# Access Compliance Report

## Public Rights-of-Way

### (Pedestrian Signals)

| ADA ID: DA3420B84867                    | Signal Type: Two Push Buttons-Non APS | Overall Compliance: No                  | Severity Score: BTN 1:N/A BTN 2: N/A No BTN: N/A |

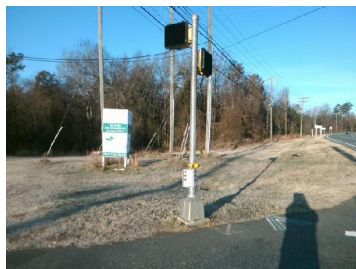
Possible Solutions: Replace Signal Push Button With APS Button on New Post. Remove & Relocate Sign.

PROW/ADA: R209.1, TMUTCD 4e.08, R404.3, R404.1, R404.7.1, R404.7.2
